U.S. Department
of Transportation
**Federal Highway
Administration**

September 11, 2007

In Reply Refer To: HSSD/B-162

In his letter of May 7, 2007, Mr. Dallas James of Armorflex Ltd requested formal Federal Highway Administration (FHWA) acceptance of a new steel strong post (called the Nucor Steel Post) for use in a new 31" (787 mm) high Nucor Strong Post W-beam guardrail system with no blockouts in both roadside and median applications. He also requested formal FHWA acceptance of the Nucor Steel Posts as a substitute for other approved posts in the standard 27" (686 mm) high non-proprietary strong post W-beam guardrail systems with the use of an original plastic blockout. This request was limited to roadside applications only. To support his request, Mr. James also provided a copy of a Holmes Solutions Limited test report dated March 2007, entitled "31 Inch Nucor Strong Post W-Beam Guardrail without Blockouts" and a copy of a Holmes Solutions Limited test report dated March 2007, entitled "27 Inch Nucor Strong Post W-Beam Guardrail with Plastic Blockouts." Mr. James also provided copies of the drawings, test videos, photos, raw data and analysis files and a copy of the correspo

Typical Median installation with Nucor U post

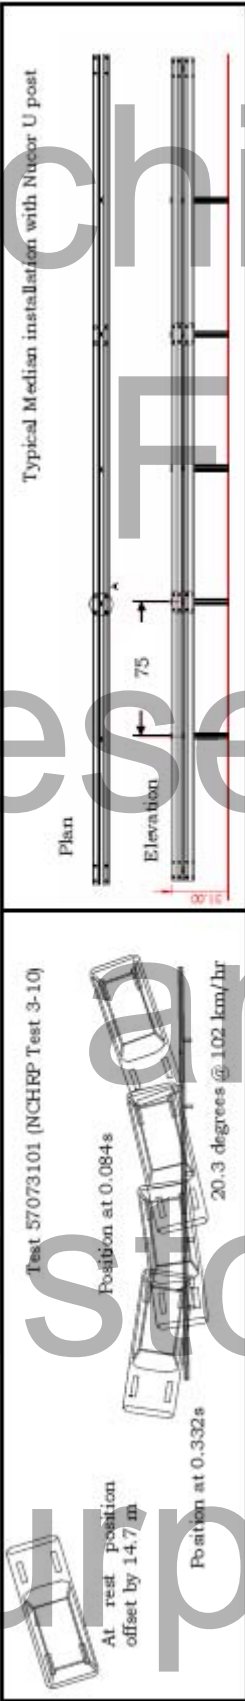
- Test 3-10 which used a 820C car impacting the system in the median configuration, and
- Test 3-11 which used a 2270P truck impacting the system in the roadside configuration.

I agree that the selected program is optimal for a full-crash testing of Nucor Strong Posts with the above W-beam guardrail systems. Test 3-10 on the median barrier configuration of the new Nucor Strong Post W-beam guardrail system is considered to produce the greatest risk to the occupant's safety as it is stiffer than the roadside configuration and has a similar potential for snagging. Further, while the proposed updates to the NCHRP 350 recommend the replacement of the 820C with a 1100 kg passenger car (1100C), test 3-10 using a 820C vehicle would produce higher occupant risk than the 1100C vehicle. Also, I agree that the decision to complete Test 3-11 only on the roadside configuration of Nucor Strong Post W-beam guardrail system is justified as this system is structurally less stiff than the median barrier configuration. Using of the 2270P truck (proposed in the updates to NCHRP 350) in this test as opposed to the currently used 2000P truck is in line with the objective to test structural adequacy of the system.

In the conducted tests no detached elements, fragments, or other debris showed potential for penetrating the occupant compartment, nor to present an undue hazard to other traffic. However, in test 3-10 one post was broken off at ground level with a large segment of the post coming to rest 6 m behind the barrier approximately 17 m downstream from the point of impact. Test videos show that the broken off part of the post was sliding at ground level before coming to rest and therefore the hazard to other traffic in median application on a level surrounding surface would be minimal. However, the described tendency of the posts to break off should be recognized and should be taken into account when selecting locations for installations. Also, this tendency may be more pronounced when the system is used in the frozen ground or when the surface is paved.

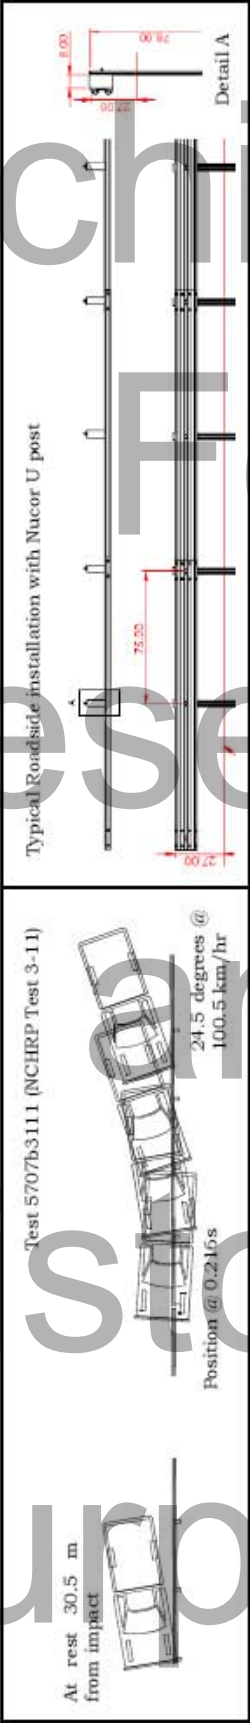
- Test 3-11 which used a 2000P truck impacting the system in the roadside configuration.

Similarly, I agree that Test 3-11 which uses a 2000P truck impacting the 27" (686 mm) high W-beam guardrail system in the roadside configuration is sufficient to evaluate the performance of this system. Conducting Test 3-10 would be redundant as the system is similar to the previously approved non-proprietary W-beam systems and is unlikely to cause any concerns in impacts with a small car.
